**DATE:** January 30, 2024

**TO:** Council Transportation Committee

**SUBJECT:** Interim Castro Pedestrian Mall--Central Walkway Street Treatment Concepts

**Concept 1: Ribbons**

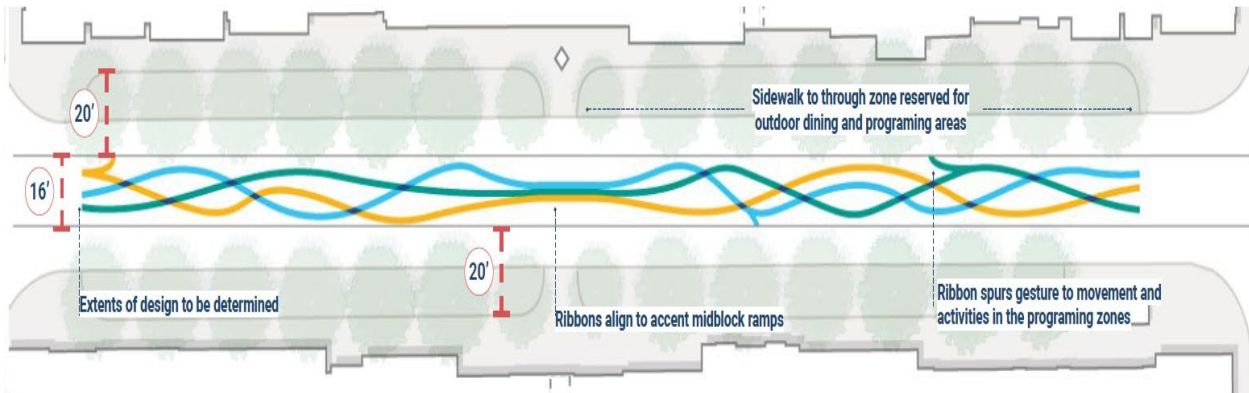
1. Approve the ribbon concept with more coverage (up to 70%) by expanding the ribbon widths. (6-1 vote)
2. Approve the design with the colors as proposed. (7-0 vote)
3. Recommend that the City use the Streetbond Water-Based Pavement Coating instead of the Acrylic Asphalt Paint so that the treatment can be power washed. (6-1 vote)

The ribbon concept as presented provided approximately 55% coverage. Staff can explore expanding or widening the ribbon widths for more coverage; however, staff recommends the coverage be balanced with ensuring the ribbons provide the sense of movement and flow envisioned.
